ENGINE - HP COMPRESSOR - DELETION OF THE HEAT SHIELD AT THE OUTLET GUIDE VANE INNER
CASE LOCATION - CATEGORY CODE 6 - MOD.ENG-72-0143

V2500-ENG-72-0143

SERVICE BULLETIN

Location of heat shield
Fig.1

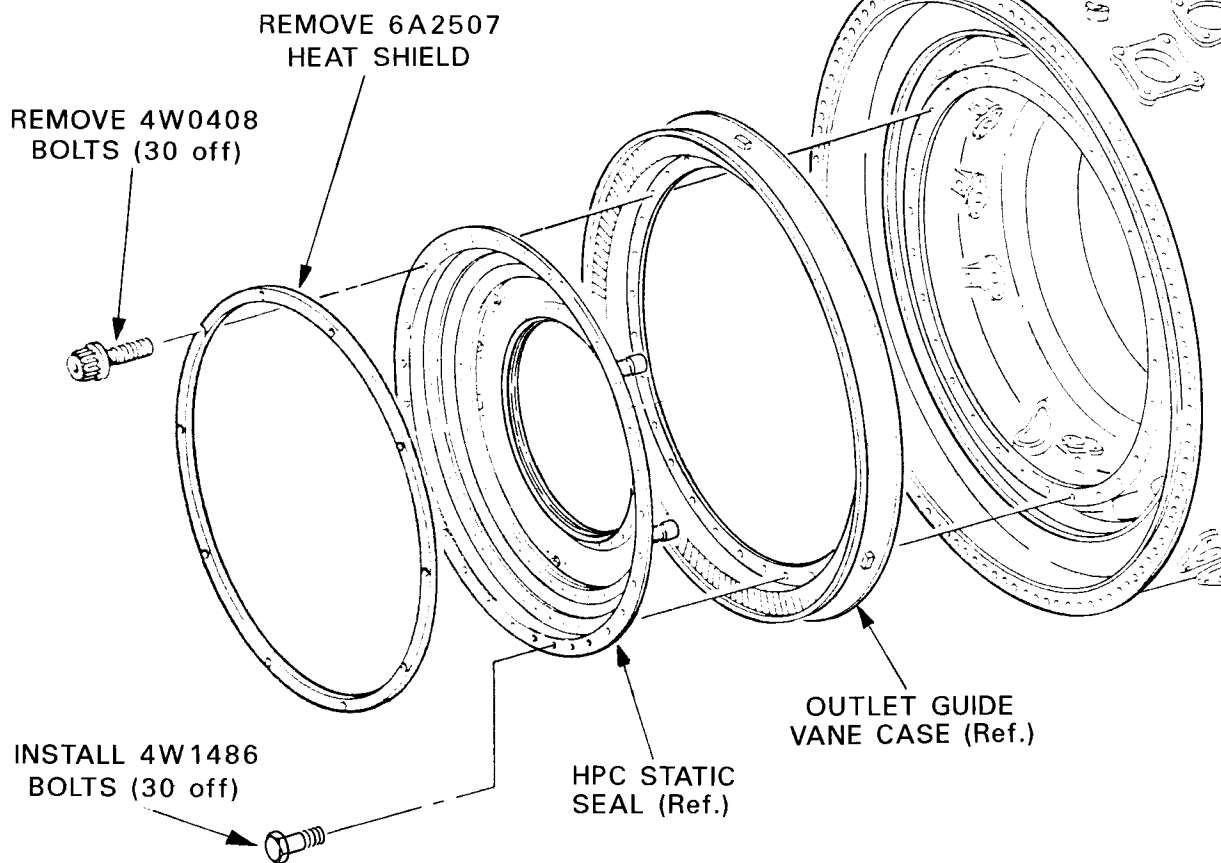
The outlet guide vane case on the HP compressor module is secured to the diffuser case by 30 bihex bolts. To minimise possible disturbance of the gas flow caused by the protruding bolt heads a shield is located over the heads. This shield was originally considered to be necessary to ensure that generation of 'windage' heat into the cavity behind the stage 12 rotor disc did not occur.

- (a) The heat shield at the outlet guide vane case inner location is deleted.
- (b) The 30 bihex head bolts securing the shield to the diffuser case are replaced with lower profile plain hex. head bolts whose projection is less than half that of the existing bolts.
